Service Bulletin

Category B	Applicable Model/s 1995 - 96 Millenia	Subject No. 1 ENGINE MOUNT MODIFICATION	Bulletin No.	001/96
			Issued	04/18/96
			Revised

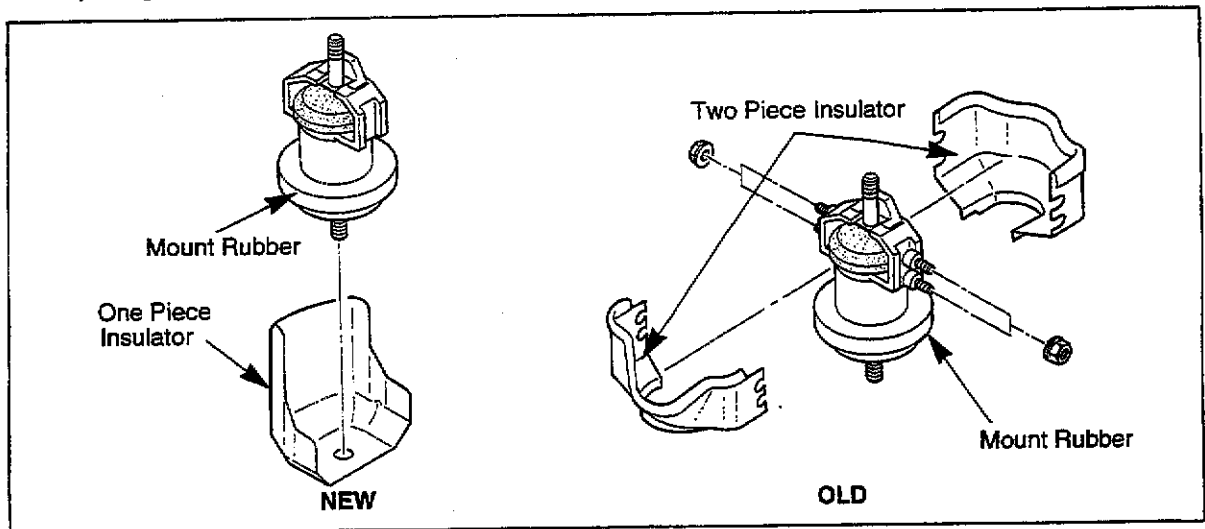
To improve efficiency during production, the No. 1 engine mount rubber and insulator design have changed. The changes are shown below.

NOTE: This change could affect replacement part orders. Dealer personnel should inspect the vehicle prior to placing orders.

Interchangeability Note: The new and old parts are not interchangeable between each other. Set "A" and "B" (shown below) can be used in place of each other.

**** 39 040C
T001 39 621
T001 39 611
Set "A"

**** 39 040D
T002 39 621
Set "B"
